Subject: Additional Criticality Safety Demonstration for the New Powder Container (NPC)

References: (1) Docket 71-9294, USA/9294/AF-85, TAC No. L23355
(2) Recent telephone conversations between NRC and GNF

**eDRF No. 0000-0006-6390 [ADDENDUM 1]
Criticality Safety Analysis
New Powder Container
Single Damaged Unit – Heterogeneous Study**

1.1. Request for Additional Information

Figure 3a. Original Results with Uniform Rod Arrays

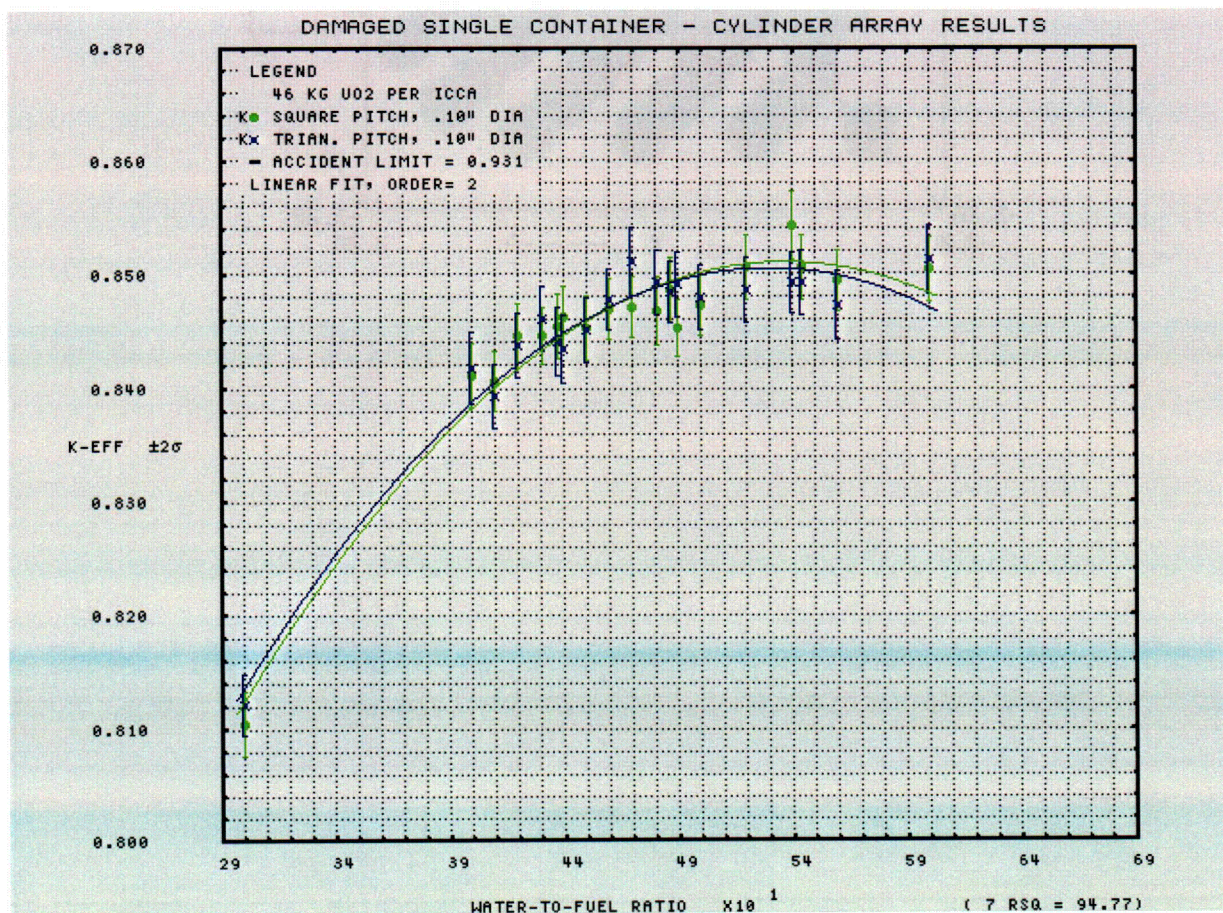
"Can you confirm that optimally moderated spheres of the appropriate diameter have been considered in the criticality assessment? Or have only optimally moderated pins been considered."

"You stated that 'the "ordered array" treatment in which the right circular cylinder elements are spaced through optimum water-to-fuel ratio ... sufficiently bounds a random distribution of pellets/particles, in which physical suspension of the fuel material is not physically possible.

The original results for 0.10" diameter cylinders from the uniform rod array treatment are shown in **Figure 3a** using second order linear regression fits. The curves show no significant difference between the square pitch and triangular pitch models. From the curves, the estimated expected peak value is 0.851. The maximum value reported in Reference 1 is 0.854 is 0.03 higher than the expected maximum.
